Subject: **8015-M4 Overhead Door Improvements/DPF**

ADDENDUM NO. 3

**WORCESTER FIRE STATION #2 SOUTH DIVISION BUILDING RENOVATION
Worcester, Massachusetts**

Addendum Date: July 6, 2023

EX/DEMO FLR PLANS & ELEV., DEMO NOTES, PART. FLR PLANS & ELEV., DOOR INFO & NEW WORK NOTES

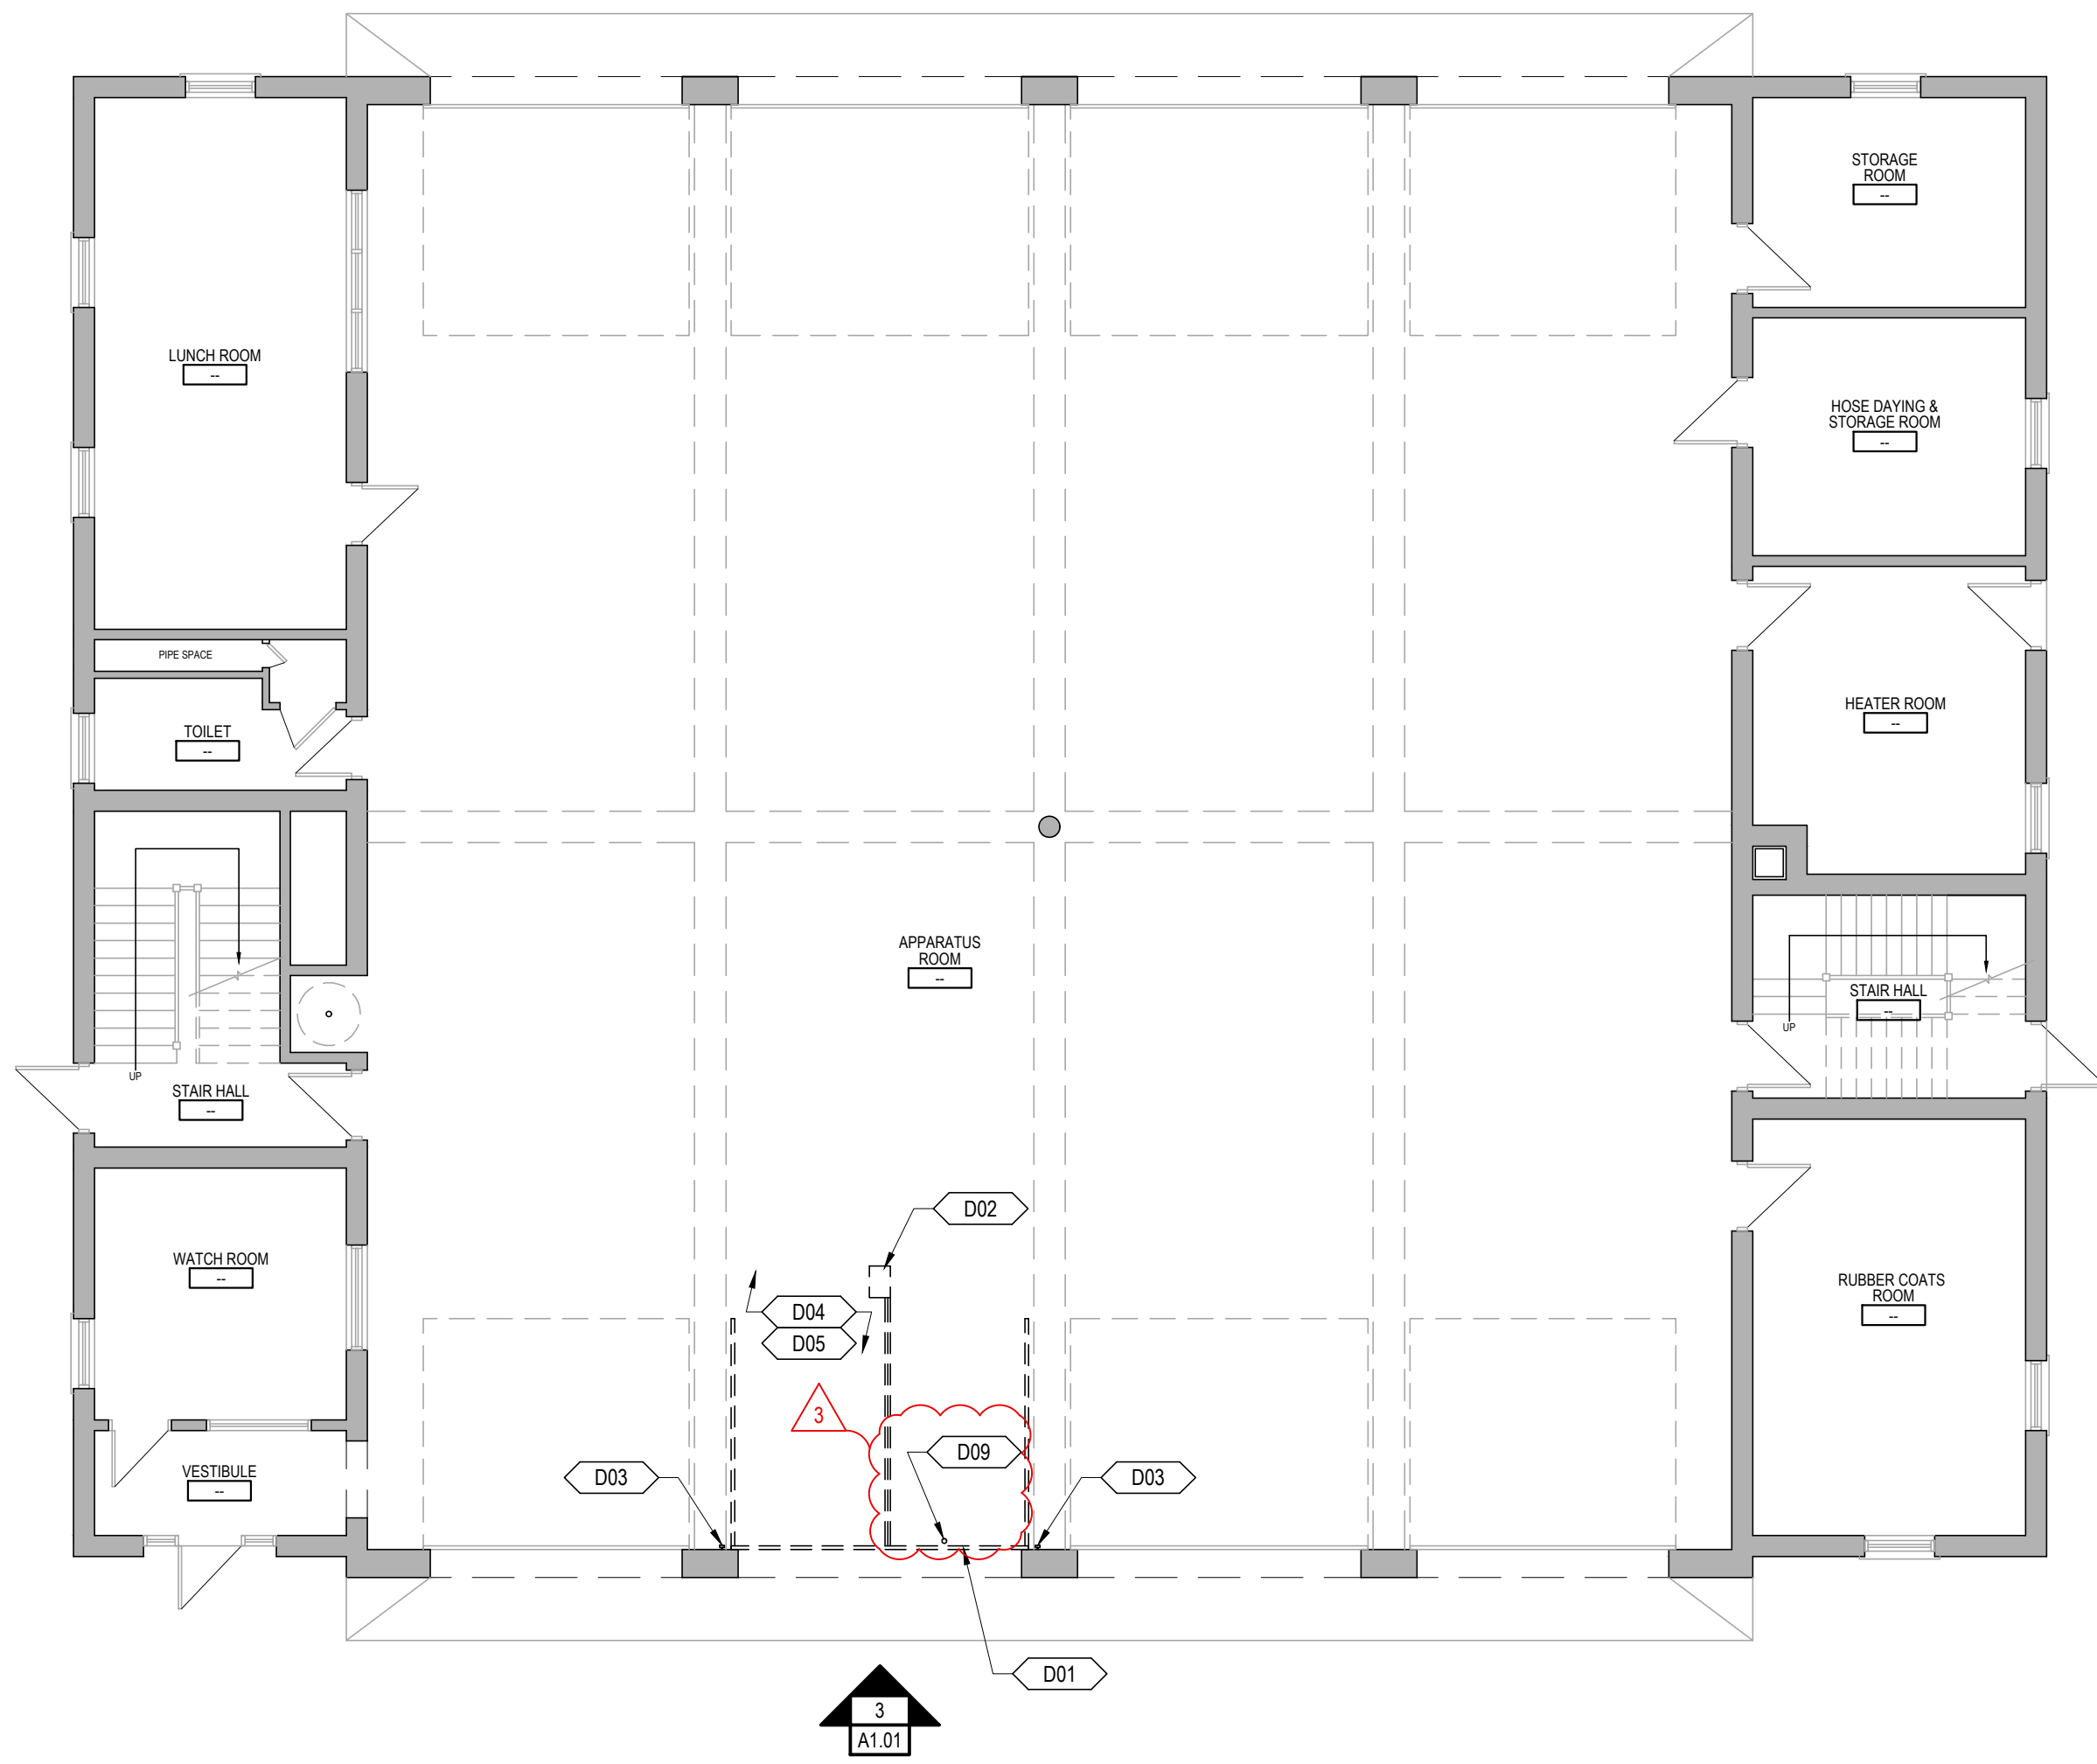
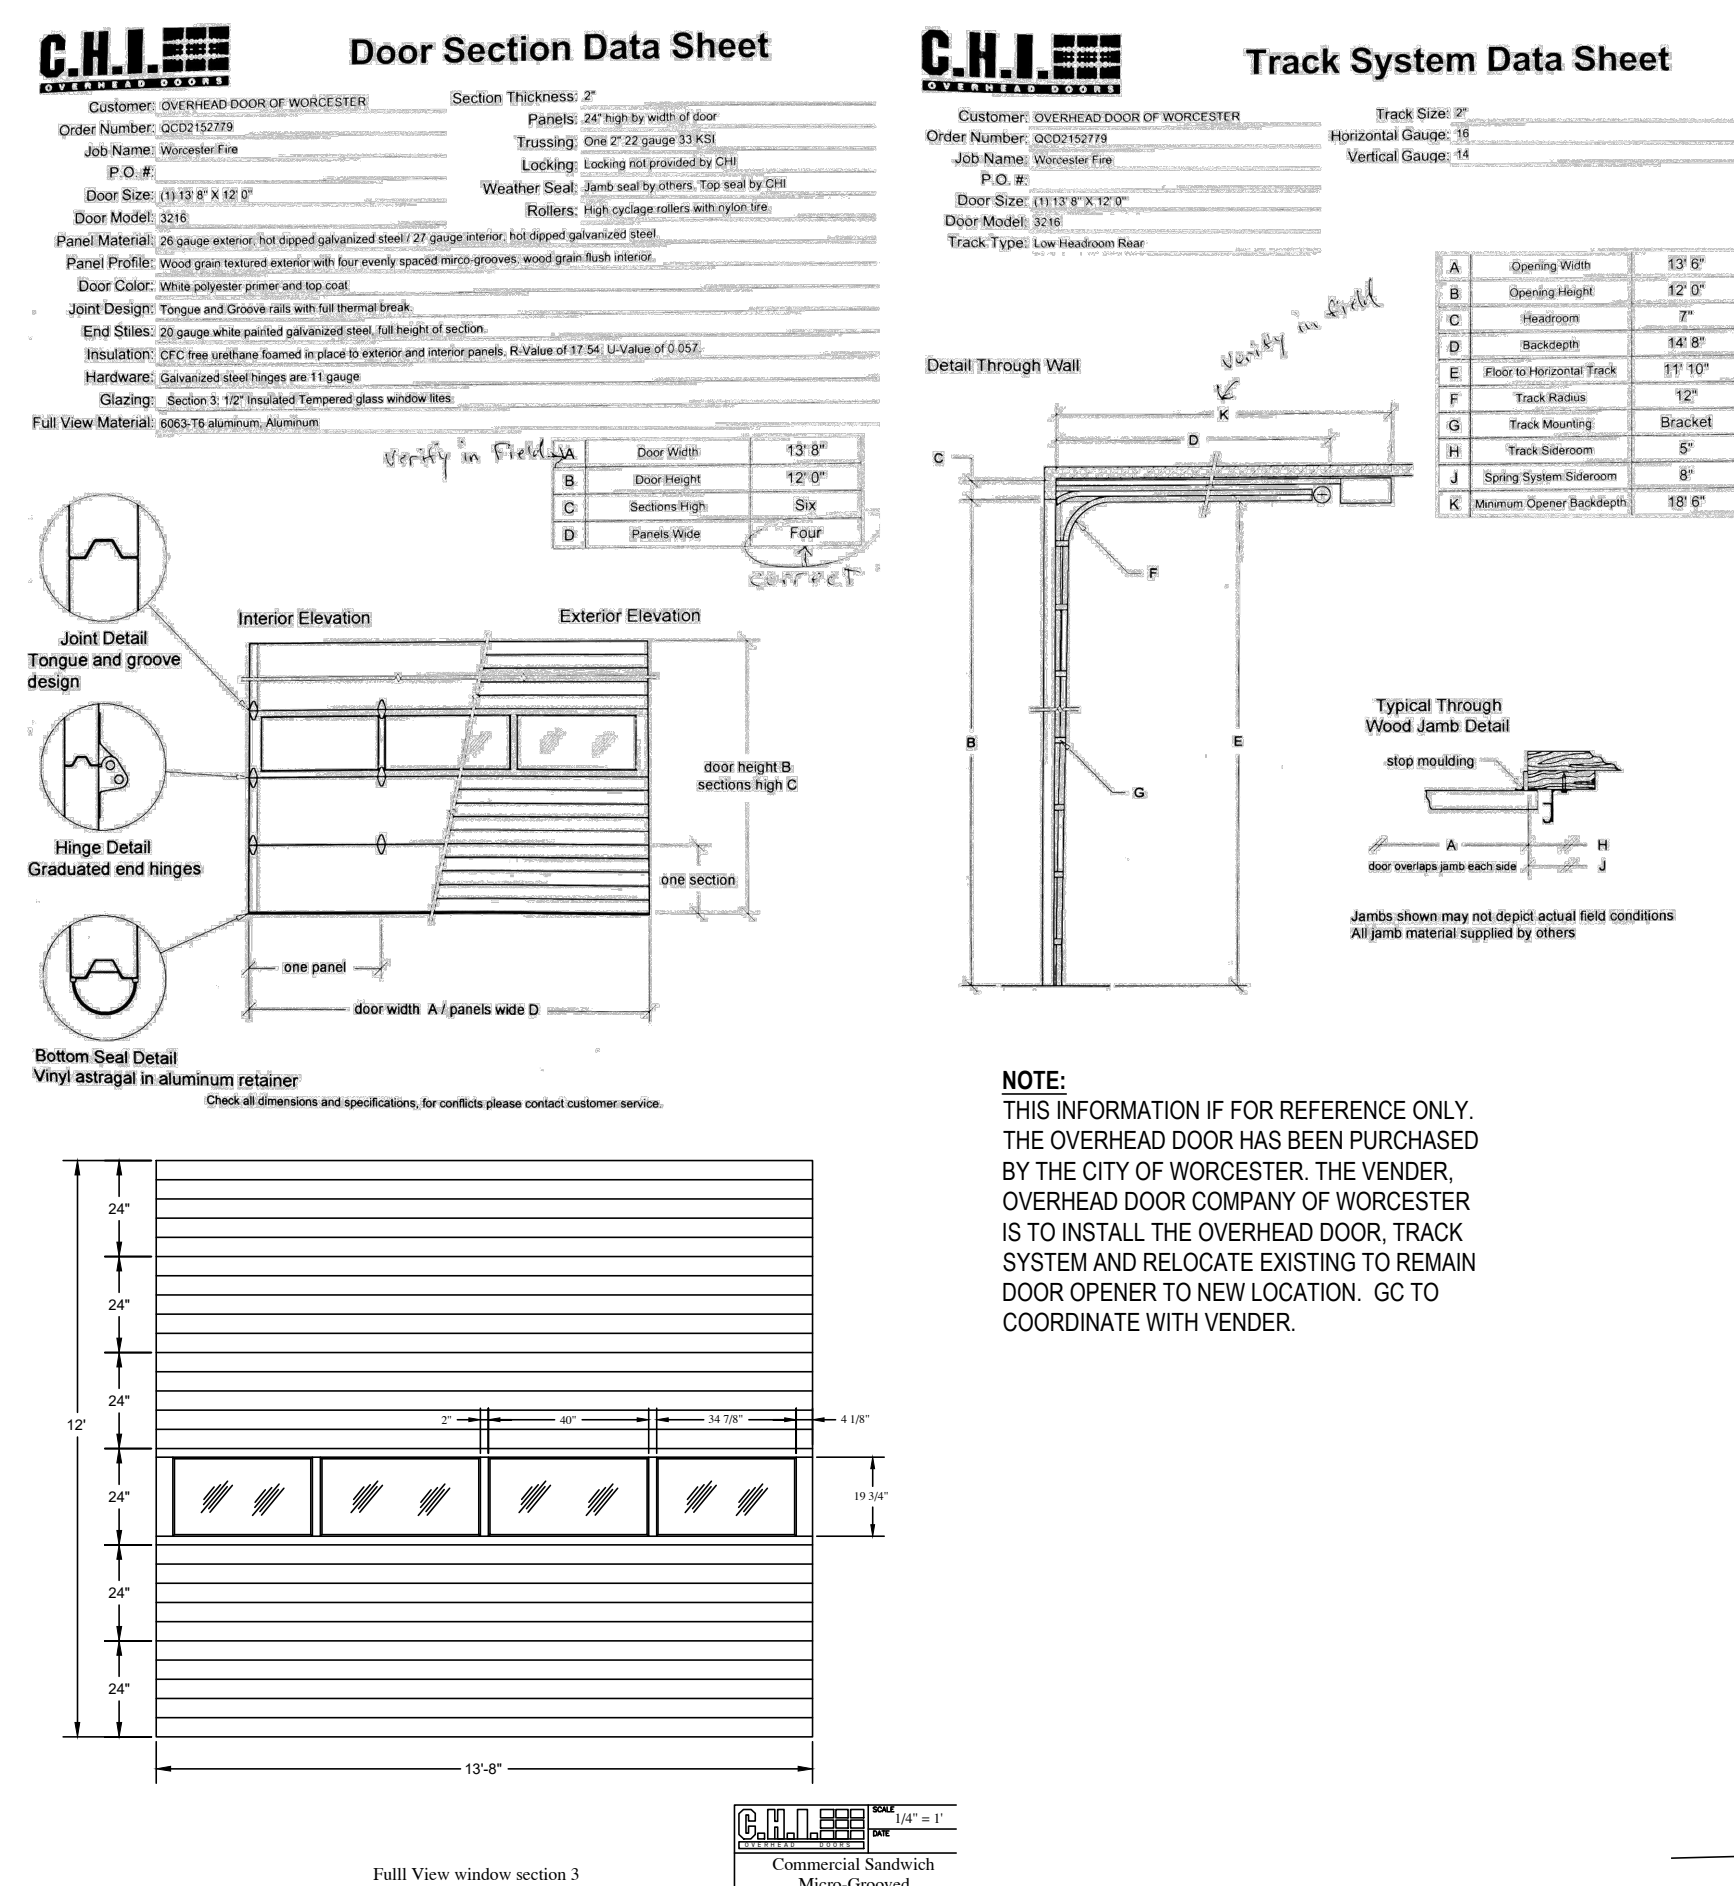
- D01 EXISTING OVERHEAD DOOR & ASSOCIATED TRACK SYSTEM TO BE REMOVED IN ENTIRETY. ABATEMENT TO BE DONE FOR EX. OVERHEAD DOOR CASING CAULKING. REFER TO SPECIFICATION SECTIONS 01 35 43 -HAZARDOUS MATERIALS PROCEDURES & 02 28 20 -ASBESTOS REMEDIATION.

- D02 EXISTING DOOR OPENER MOTOR & OPERATOR & ASSOCIATED MOUNTING BRACKETS TO BE REMOVED WITH CARE AND STORED IN SECURE LOCATION FOR LATER REUSE.
- D03 EXISTING SENSING EDGE & PHOTO ELECTRIC SAFETY SENSOR TO BE REMOVED AND SALVAGED WITH CARE AS REQUIRED FOR NEW WORK THEN REINSTALLED.

- D06 PORTION OF EXISTING MASONRY WALL TO BE REMOVED AS INDICATED ON ELEVATION. REMOVE EXISTING WF 14 STEEL BEAM HEADER WITH CARE. STORE IN SECURE LOCATION, CLEAN & PREP FOR LATER POSSIBLE REPOSITIONING & REUSE. SEE STRUCTURAL DRAWINGS.
